**PLANNING DIRECTOR'S
PLAN REVIEW MODIFICATION
(P92-264)**

Application: Planning Director's Modification to modify an
approved Plan Review for a proposed 13,000
square foot warehouse building.

Location: 4620 Raley Blvd., APN #238-0011-032-0000

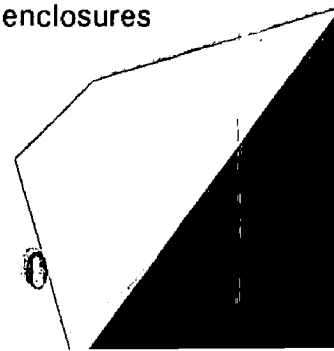
been required under the original approval. The applicant's proposal to incorporate a loading dock into the design of the 13,000 square foot warehouse building will bring the existing development into conformance with the parking requirements as listed in Section 6 of the City's Zoning Ordinance

In order to analyze the project Planning staff visited the subject site and noted that the existing building had several pieces of mechanical equipment located on the roof that had not been screened. As the subject site is located within an area designated as industrial park, Planning staff recommends that the applicant incorporate a mechanical screen around the roof of the proposed warehouse building prior to issuance of a building permit. During staff's inspection of the subject site it was also noted that vehicles were being parked on unpaved surfaces and there was open storage of materials. The Zoning Ordinance requires that all vehicles be parked on an approved paved surface with the required landscaping, shading and irrigation. In addition, the Light Industrial Park Review (M-1SR) zone requires that all outside storage be screened with a solid wall or fence. On June 25, 1991, the City Council adopted a Recycling Ordinance which requires all new developments to incorporate a recycling plan for the development and provide adequate space for recycling on the subject site. The applicant should be aware that the new building will be subject to the City's Recycling Ordinance.

1. The applicant shall incorporate a parapet and/or some other similar type of mechanical screening around the roof of the proposed building in order to provide a visual screen. A roof plan with details on the screening shall be submitted to the Planning Director for review and approval prior to issuance of a building permit;
2. All vehicle parking areas and outside storage areas shall be paved in accordance with Section 6 of the Zoning Ordinance;
3. All outside storage areas shall be screened with a minimum 6 foot high solid fence or wall. If a chain link fence is to be utilized, vinyl slats shall be installed in the fence;
4. The applicant shall submit a recycling program as required in Section 34 of the Zoning Ordinance and shall incorporate the necessary trash enclosures into the project plans; and
